CAMDEN TOWN HALL

LBC Condition 5 (ref: 2020/0214/L)

Further information provided following meeting presentation 29/07/20

1.0 FURTHER IMAGES OF SELECTED PORTLAND STONE SAMPLE – BROADCROFT WHITBED

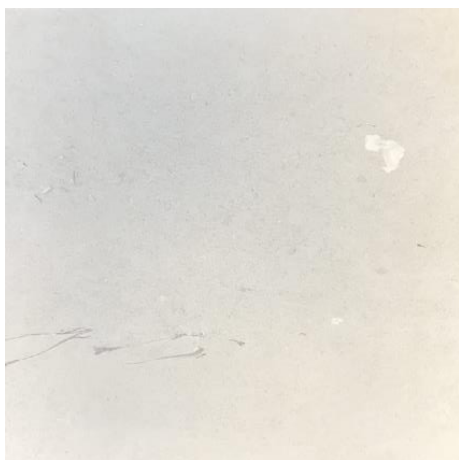
CH comment: The sample looks smooth in comparison to the existing façade.

The above image shows the proposed sample against an area of existing cleaned Portland stone, which demonstrates a visible variation of texture in the existing façade – some smoother areas, some slightly rougher. Specialist stone contractor has also confirmed that the new stone will weather over time resulting in a slightly rougher finish.

2.0 IMAGES OF OTHER NON-PREFERRED PORTLAND STONE SAMPLES

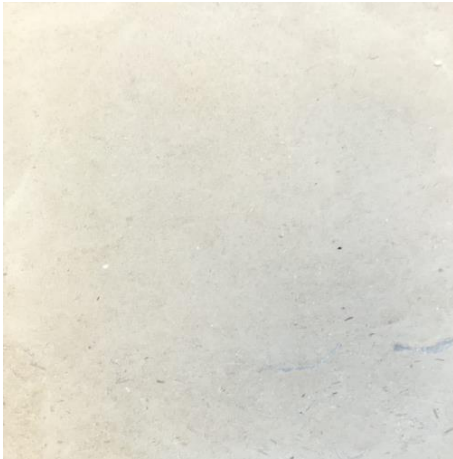
CH requested to see the other Portland Stone samples reviewed to support to rationale of selected Portland Stone.

The initial image shows the preferred sample being held against the clean section of façade and the rejected samples below. It was deemed that the selected sample had the best match in terms of colour, grain, and texture.
